# Service Bulletin

**SUBJECT:** Service Update for Inventory and Customer Vehicles  
4-Wheel Drive Transfer Case Adapter Housing  
Expires with Base Warranty

**MODELS:** 2013 Chevrolet Silverado HD  
2013 GMC Sierra HD  
Equipped with 4WD and 6-Speed Automatic Transmission (MW7)

Subject: 13346 – Service Update Bulletin  
4-Wheel Drive Transfer Case Adapter Housing

Numbers shown in the photograph above do NOT fall under the suspect parts. (1) Location of Traceability Numbers. (2) Machine Number (3) Fixture Number (4) Shift Sequence Number (5) Machine Julian Date.

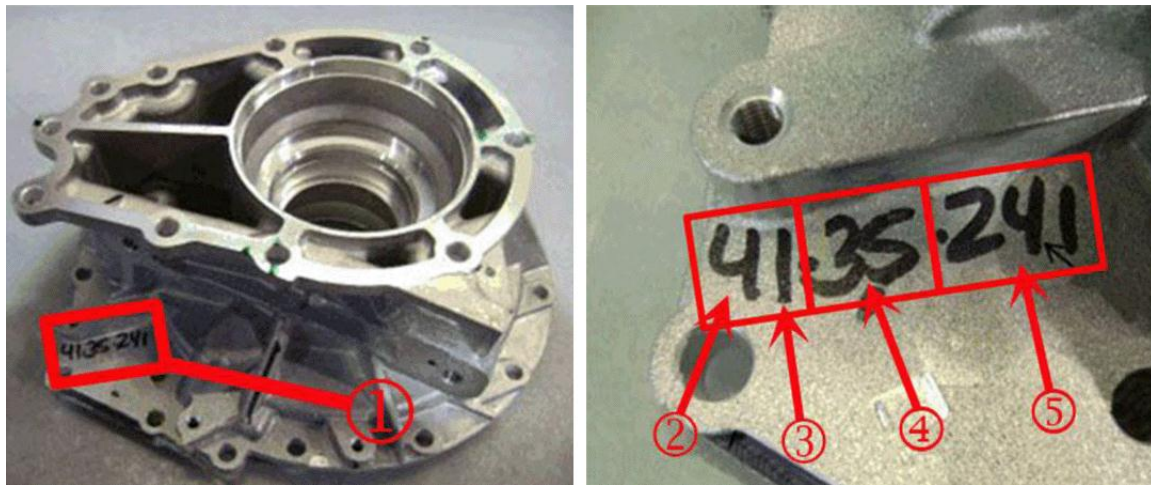
2. Locate the traceability number on the transmission low reverse clutch housing (1). The traceability number was written with a black paint marker.

3. Determine the traceability number written on the low reverse clutch housing. The number includes a machine number, fixture number, shift sequence number and machine Julian date. Refer to the photograph to review the breakdown of the traceability number.

- If the traceability number includes a machine and fixture number of black 31 or 32 and machine Julian date of 254, proceed to step 4.
    - If the traceability number includes machine and fixture numbers other than black 31 or 32 or a Julian date other than 254, no further action is required. Lower the vehicle. Refer to *Lifting and Jacking the Vehicle* in SI.
